**Mobile Bay National Estuary Program  
Government Networks Committee  
Structural Integrity Review for Alabama Power's Plant Barry CCR Closure Plan  
Zoom Meeting  
May 4, 2020  
1:30-3:30 P.M.**

Next, Christian introduced Robert (Bob) Snow, P.E. with D'Appolonia Engineering to present findings of a structural integrity review for the Plant Barry ash pond closure plan. MBNEP contracted with D'Appolonia to conduct a review of this closure plan which consisted of a limited review of permit application submittals and available design documents related to the ash pond closure.

Figure 2. Top down view of the closed and capped ash pond facility at the Alabama Power Company's Barry Steam Plant located along a bend of the Mobile River in Bucks, AL.

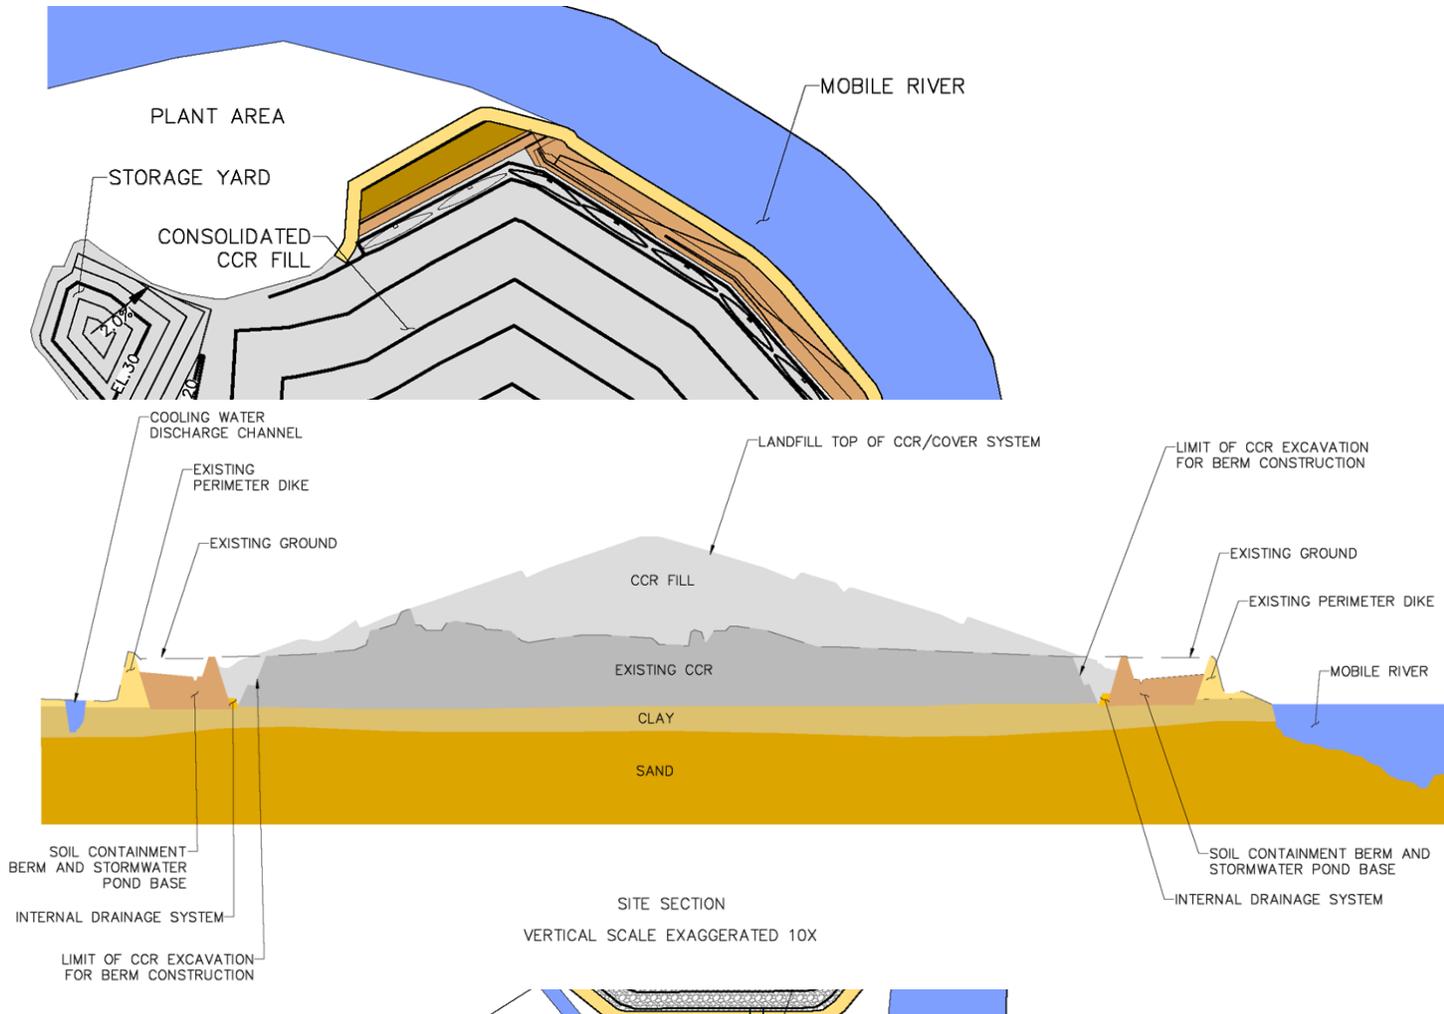
- Stability analyses indicate acceptable structural integrity and performance, with a focus on critical areas along the east, south, and west perimeters of the dike. Engineering analysis did not include the storage yard in the northwest corner of the facility.
- Successful dewatering and stabilization of the ash pond depends on pumping and removal of surface and interstitial water from the CCR. Dewatering promotes consolidation and stabilization of the ash material and allows for excavation.

- The saturation of CCR and slope stability of the storage yard area in the northwest corner should be assessed as CCR is closed in place without the soil containment berm and internal drainage system within this area of the facility.
- Geotechnical exploration, instrumentation, and monitoring should be performed during the closure process to confirm the design basis for the closure plan.
